**ADDENDUM NO. 4
TO
CONTRACT DOCUMENTS, SPECIFICATIONS AND PLANS
FOR IMPROVEMENTS TO THE
ST. JOSEPH ROSECRANS MEMORIAL AIRPORT
ST. JOSEPH, MISSOURI
MODOT PROJECT NO. 22-012A-1**

To All Bidders: You are requested to make all changes and/or additions contained in this addendum to the Bidding Documents. Failure to acknowledge this Addendum in Proposal shall result in rejection of bid. Bidders are informed that the above referenced Questions with Corresponding Answers, Contract Documents, Specifications, and Plans are modified as follows as of December 5, 2022.

Sheet A-601 Door Schedule, Types, and Details

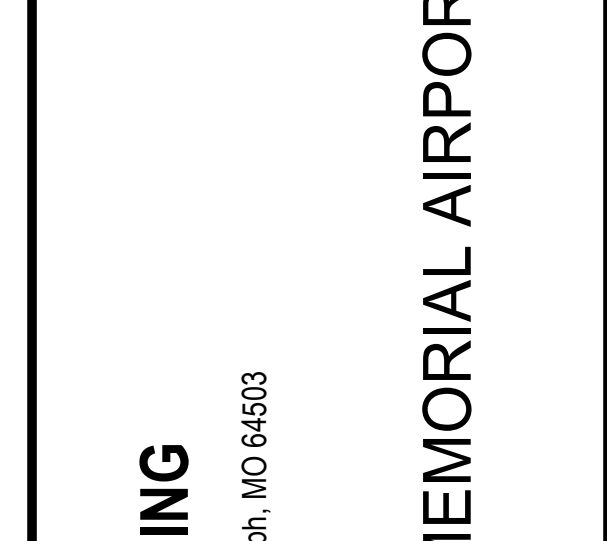
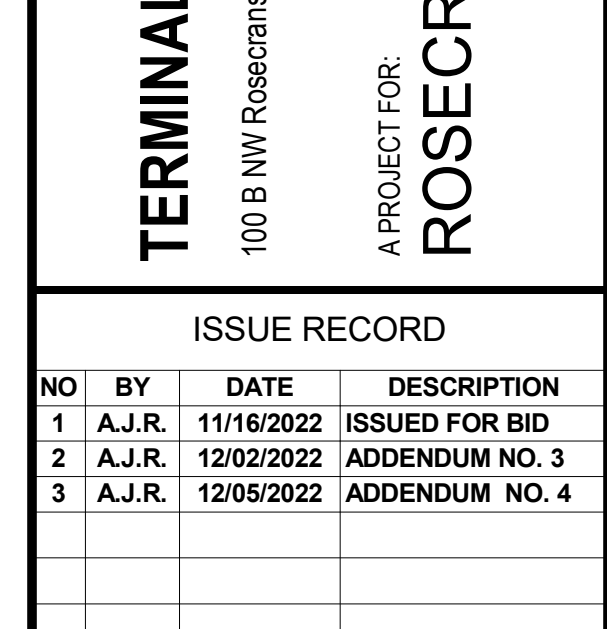
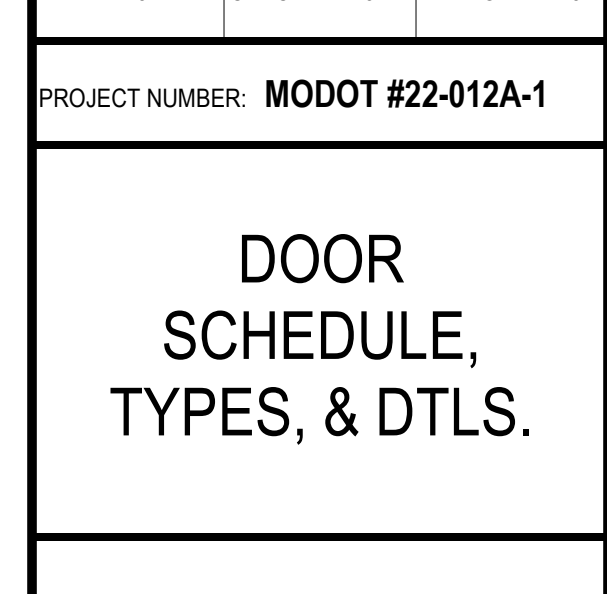
Revision: Door 011A hardware schedule updated. Door manufacturer list updated.

7. Is Door Pair 011A an overhead door hardware set?
 - a) The door Hardware Schedule has been updated per the plans.
